The Commission has issued the enclosed Amendments Nos. 20 and 25 to Facility Operating Licenses Nos. DPR-24 and DPR-27 for the Point Beach Nuclear Plant, Units Nos. 1 and 2. The amendments consist of changes to the Technical Specifications and are in accordance with your application dated October 10, 1975 and supplements dated July 12 and August 12, 1976.

POINT BEACH NUCLEAR PLANT, UNIT NO. 1

Amendment No. 20
License No. DPR-24

SUPPORTING AMENDMENTS NOS. 20 AND 25 TO FACILITY LICENSES DPR-24 AND 27

Figure 15.4.10-1 Sampling Locations

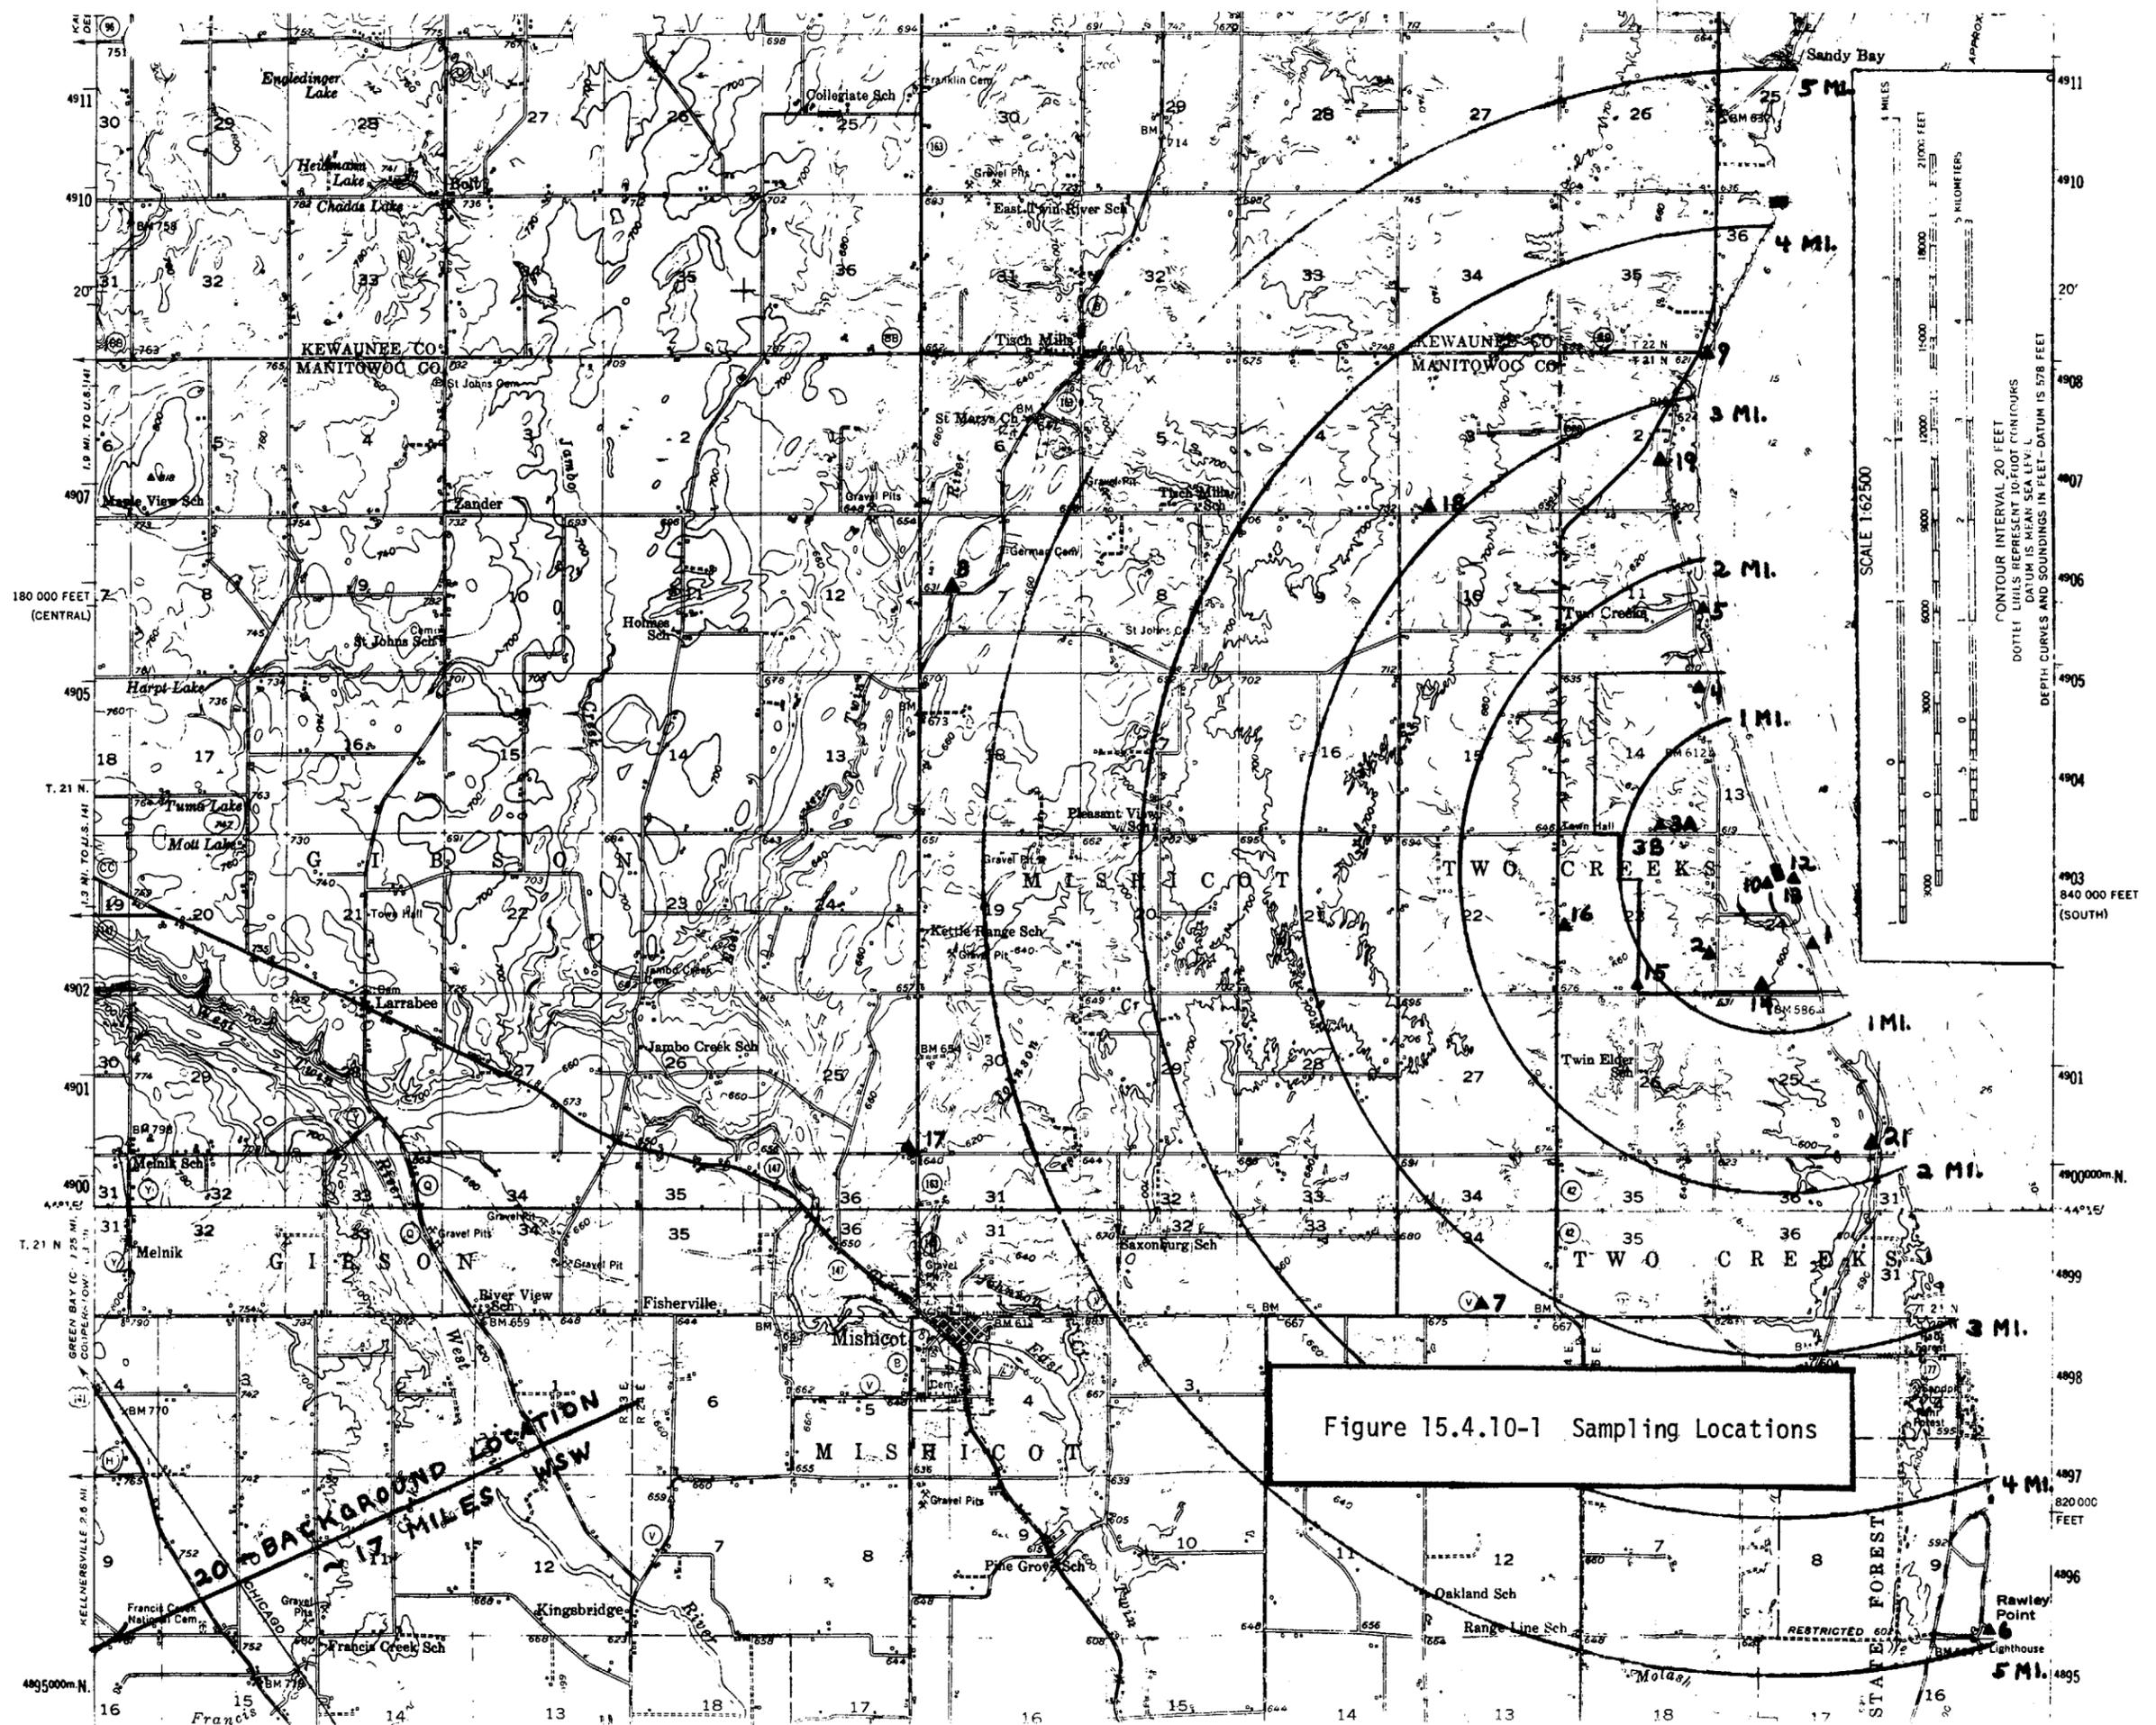
Replace pages 15.4.10-1 and 15.4.10-2 with the attached revised pages.
Add Table 15.4.10-1 (Page 1 of 2 and Page 2 of 2) and Table 15.4.10-2
(Page 1 of 2 and Page 2 of 2), and Figure 15.4.10-1.

1. Environmental samples shall be taken at locations indicated in Figures 15.4.10-1, according to the schedule given in Table 15.4.10-1 and the analytical criteria given in Table 15.4.10-2.

(c) Numbers given under location correspond to sampling locations shown in Figure 15.4.10-1.
